Vodafone New Zealand

Technical arrangement of the 3.5 GHz band

Response to Radio Spectrum Management
proposal for 3.5 GHz technical arrangement

August 2018

Figure 2. Proposed frame structure of Band n78 by MBIE

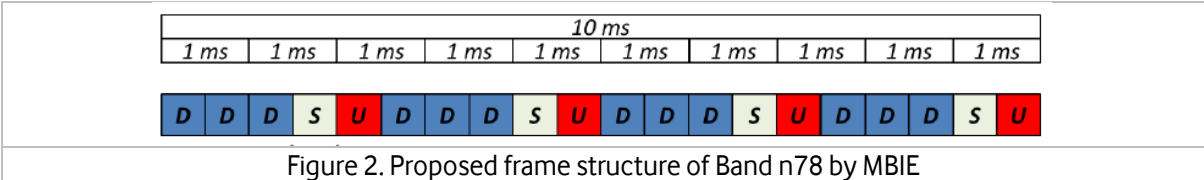
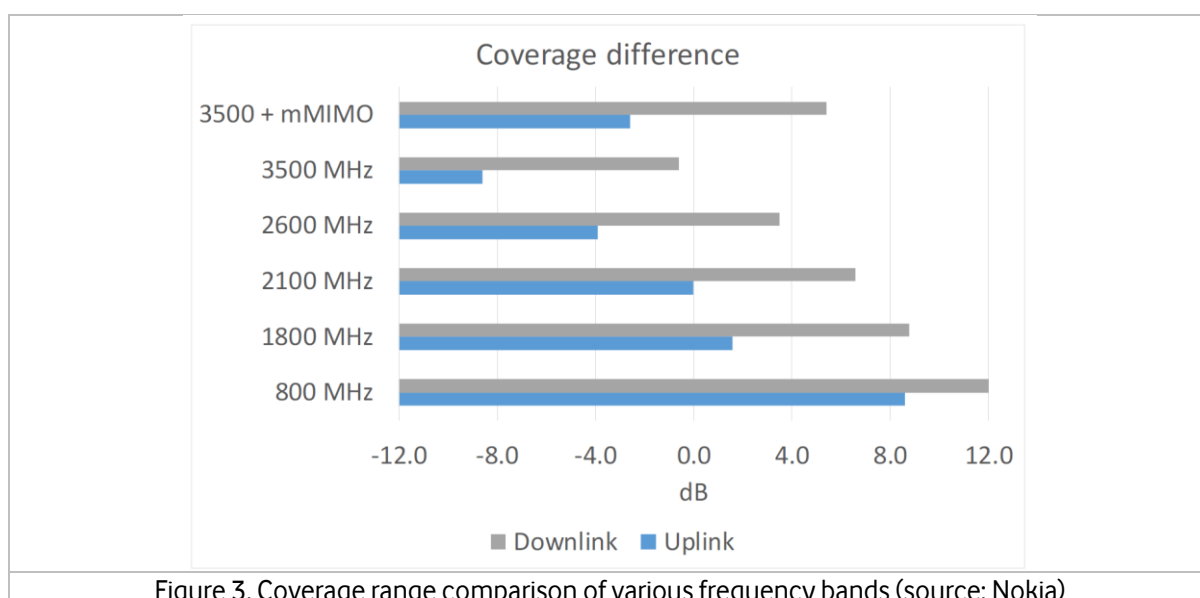
23. The frame structure “DDDSUDDDSU” proposed by RSM with 30 kHz sub-carrier spacing (SCS) is limited to a maximum of 0.5ms contiguous UL transmission period (Figure 2). Therefore, it is not possible to support any long PRACH format, restricting the practical achievable cell range to approximately 1 km only. This places a significant limitation on the possible deployment scenarios of NR in the 3.5 GHz band.

26. Vodafone recommends that the frame structure be changed to DDDSUDDSUU, while keeping the SCS the same as 30 kHz. This allows two consecutive UL transmission slots and supports contiguous UL transmission period of 1 ms, enabling long PRACH format to be implemented. This opens up the opportunity of NR n78 in rural deployment scenarios. It makes the network implementation much more flexible, and as a result, better spectrum utilisation can be achieved throughout New Zealand.
